OLD OAK INTERIM NEIGHBOURHOOD FORUM

Representation on Application 20/0012/HS2OPDC under S17 of HS2 Act – above ground works associated with Old Oak Common Station

Sketch of station entrance viewed from Wells House Road

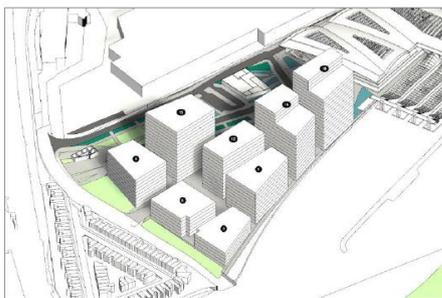
On page 22/23 of the leaflet there are two 'sketches'. The first is titled *Sketch of the station view from Wells House Road*. This shows an uninterrupted vista to the south of the station, extending as far as the Imperial College 35 storey tower in the distance on the eastern side of Wormwood Scrubs, as below.

Image from page 35 of Design and Access statement

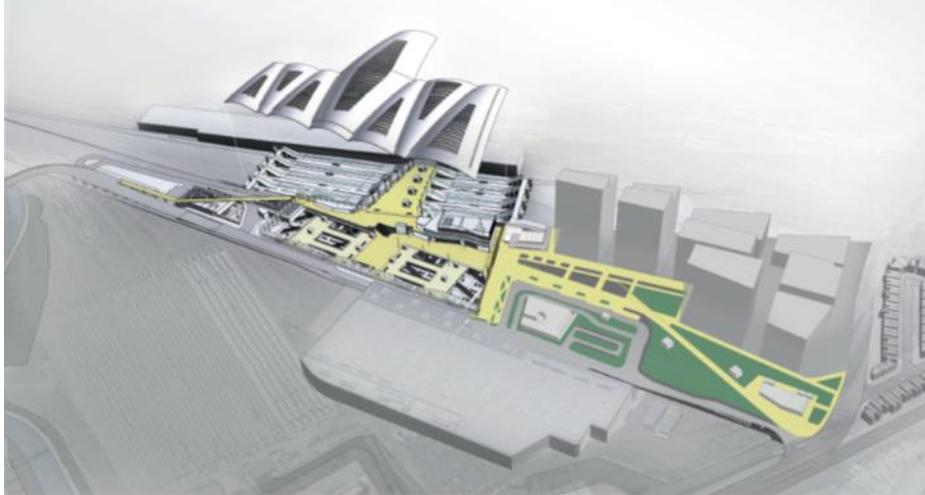
There is brief mention of the Adjacent Site at 4.3.7 and 4.3.8 of the D&A Statement submitted with the S17 application, and one image of potential development of this site is shown at Figure 15 on page 35). No buildings appear on this site in the image of *Station Approach* on page 34. The site appears as open green space in the images at Figures 18 and 19 in the sections 7 on *Architecture and Design Evolution*.

Is it reasonable to expect the general public to download and review the D&A Statement submitted with the application, when this is a 203 MB document of 147 pages split into 3 parts on the OPDC Planning Register? Many local people will have formed their impressions of the impact of the station from the February 2019 HS2 consultation leaflet. Hence public consultation on the station proposals and the works to the bridges and roads in application **20/0012/HS2OPDC** has been inadequate as a result of HS2's reluctance correct explicitly, in the text and images in the application documents, the misleading impression given during the 2019 consultation exercise.
